October 9, 2015

Mr. Bobby Bull, PE
Florida Department of Environmental Protection
Siting Coordination Office (SCO)
2600 Blair Stone Road, MS 5500
Tallahassee, FL 32399-2400

The Orlando Utilities Commission (OUC) is responding to the October 6th, 2014 Request for Additional Information from Ms. Debra Laisure of the Florida Department of Environmental Protection (FDEP) concerning the design of the lined industrial wastewater ponds at the OUC Stanton Energy Center (SEC), in Orange County, Florida. The FDEP questions and comments were issued upon review of the Engineering Report; Technical Specifications and Construction Quality Assurance Plan; and Design Drawings for Recycle Pond Expansion and Sedimentation Pond (originally designated as South Coal Storage Area Pond), which were prepared by Ardaman & Associates, Inc., dated August 25, 2014. OUC has completed and revised the design and is therefore including a complete, revised set of design drawings for your review. The FDEP questions and comments are shown below in bold format followed by the OUC responses in italicized red print.

ORLANDO UTILITIES COMMISSION

PLOTS OF STAGE STORAGE RELATIONSHIPS

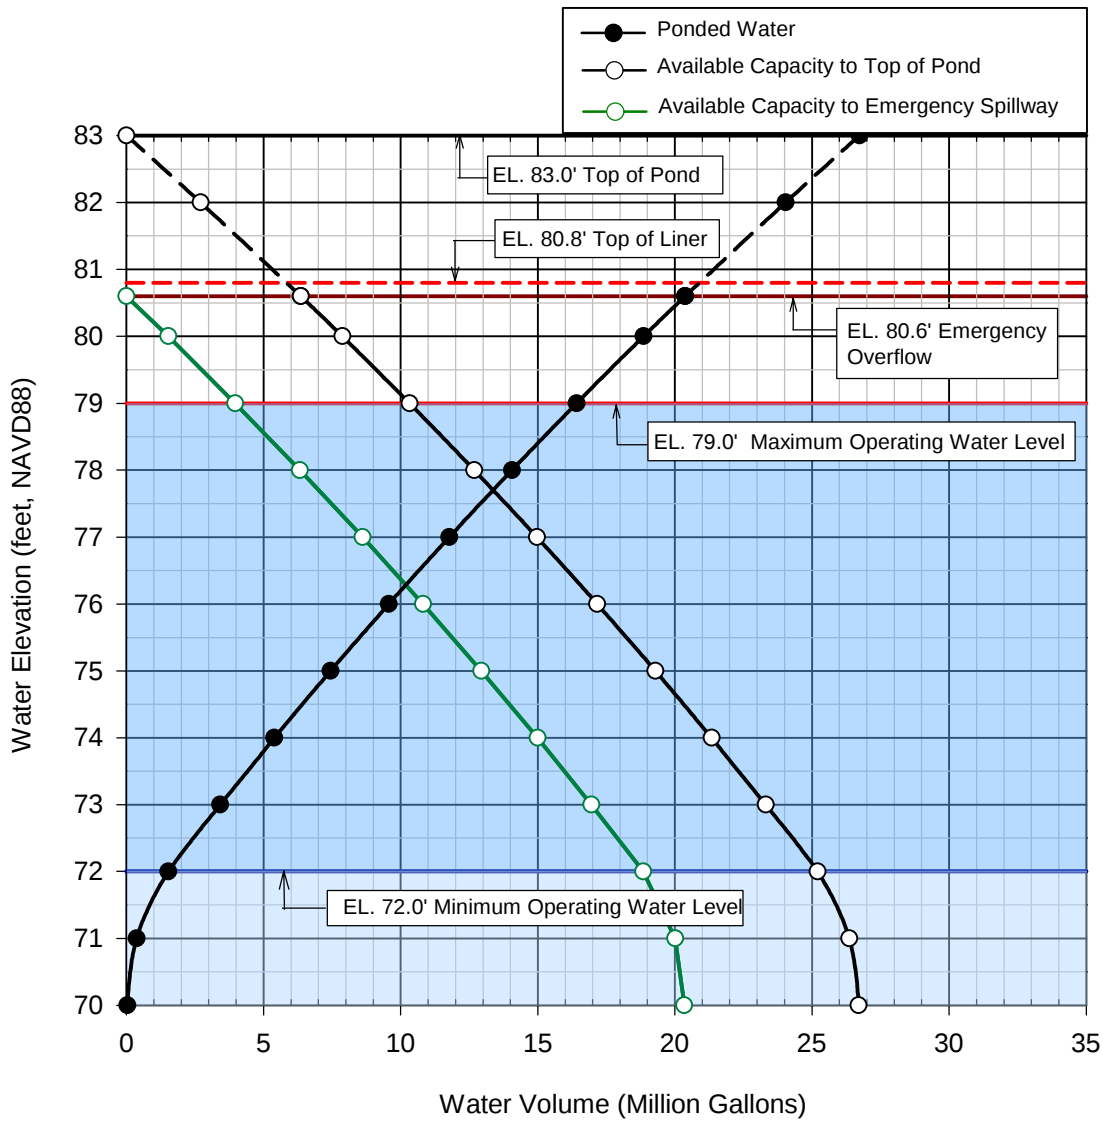
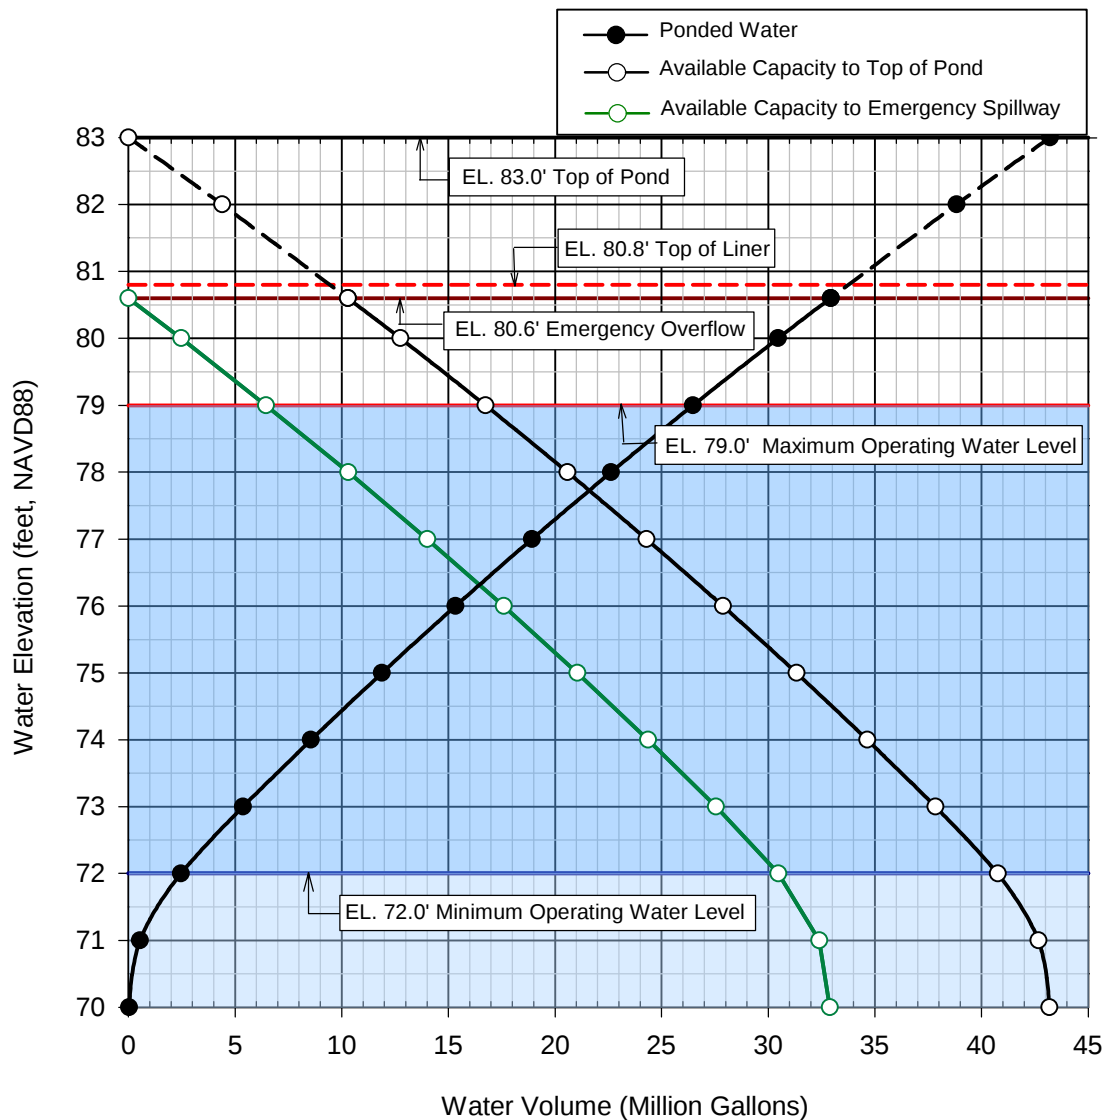
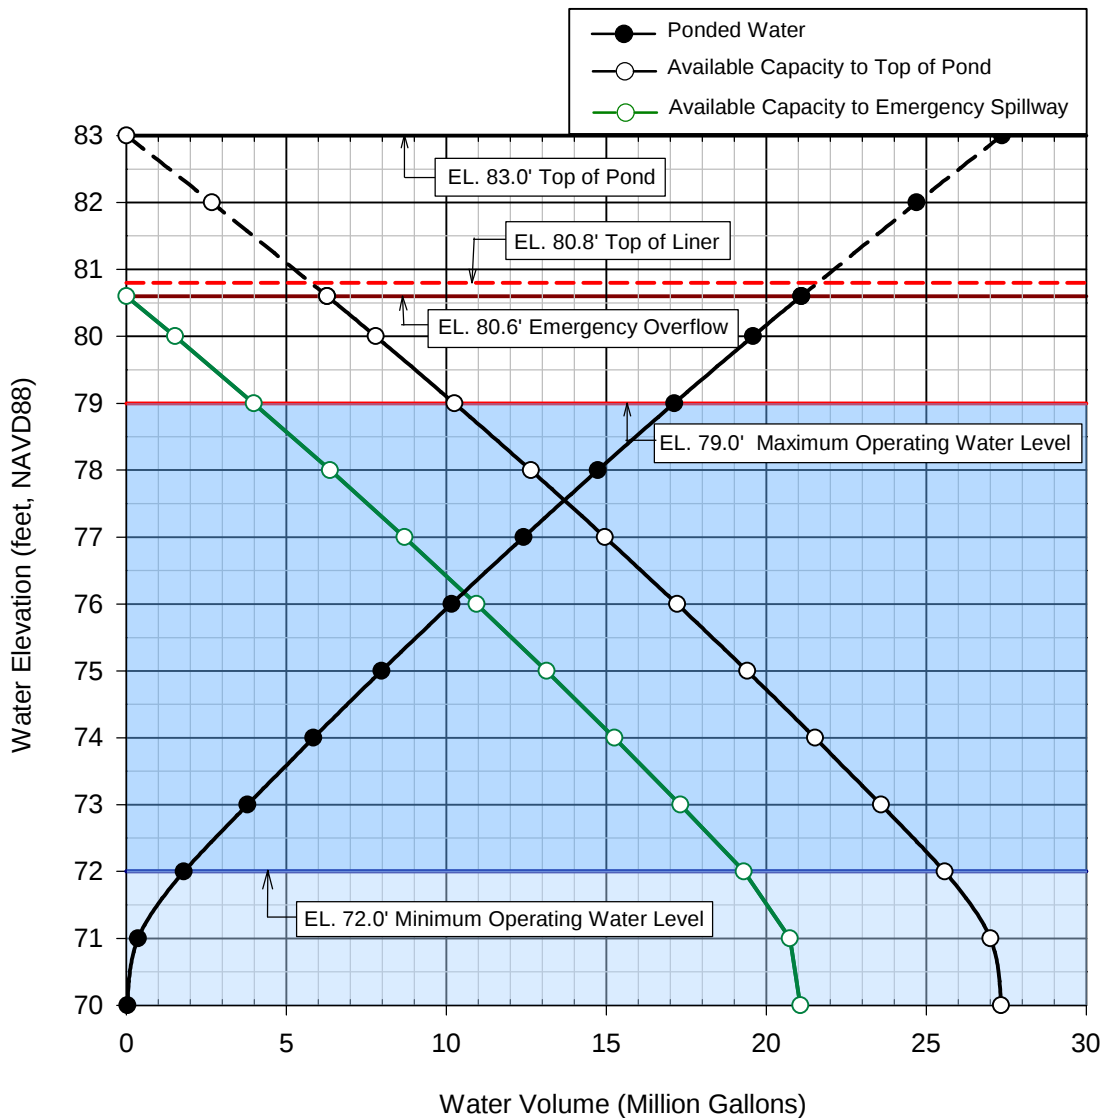
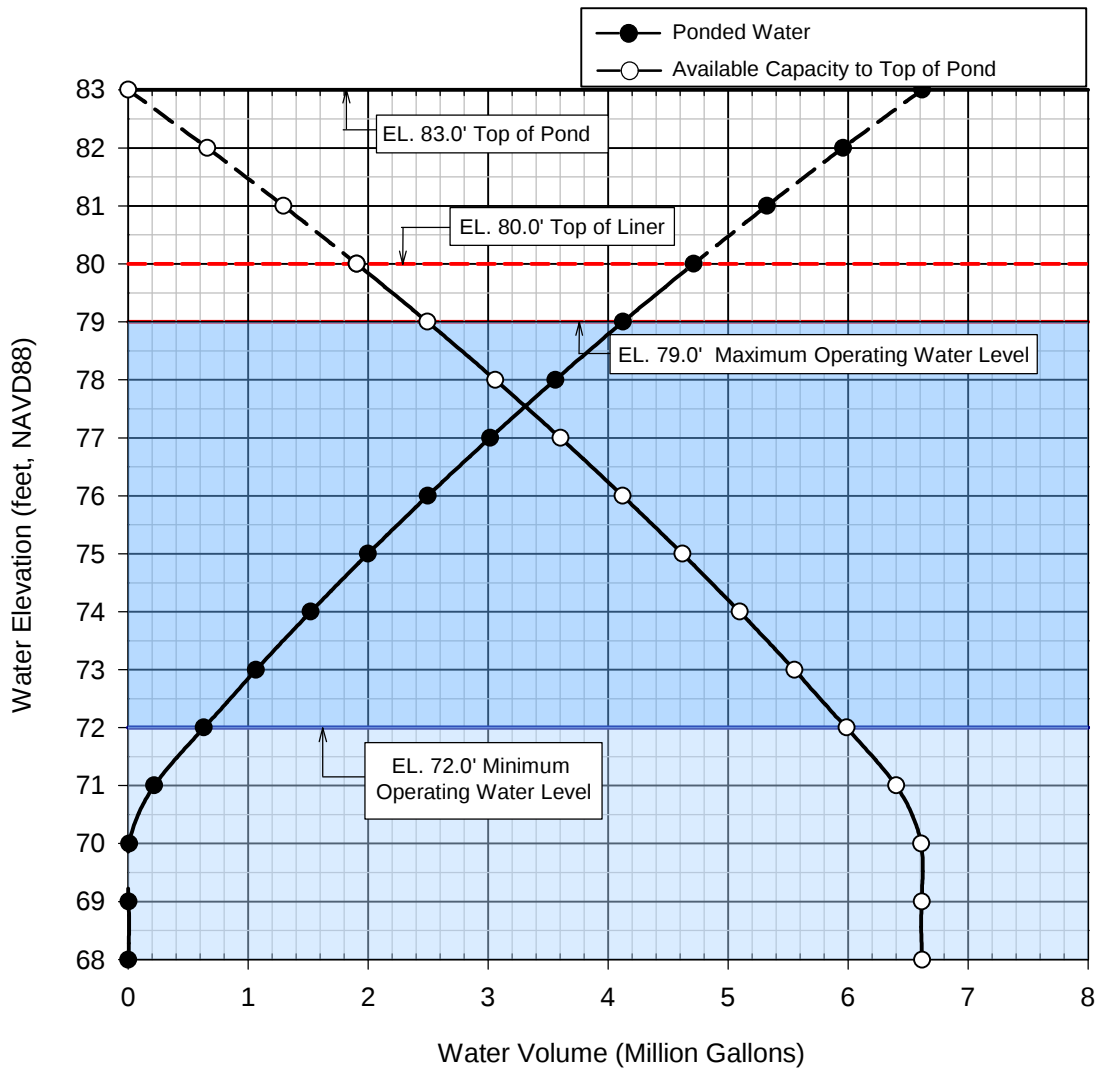
6. **Please provide complete stage/storage information for the modified Recycle Pond, the Recycle Pond Expansion, the modified North Coal Storage Area Pond, and the modified South Coal Storage Area Pond (future sedimentation pond).**

The stage storage information for the modified Recycle Pond, the Recycle Pond Expansion, the modified North Coal Storage Area Pond, and the Sedimentation Pond are presented in Tables 1 through 4 of this response, respectively. Plots of stage storage relationship for each pond are presented in Appendix 1 of this response.
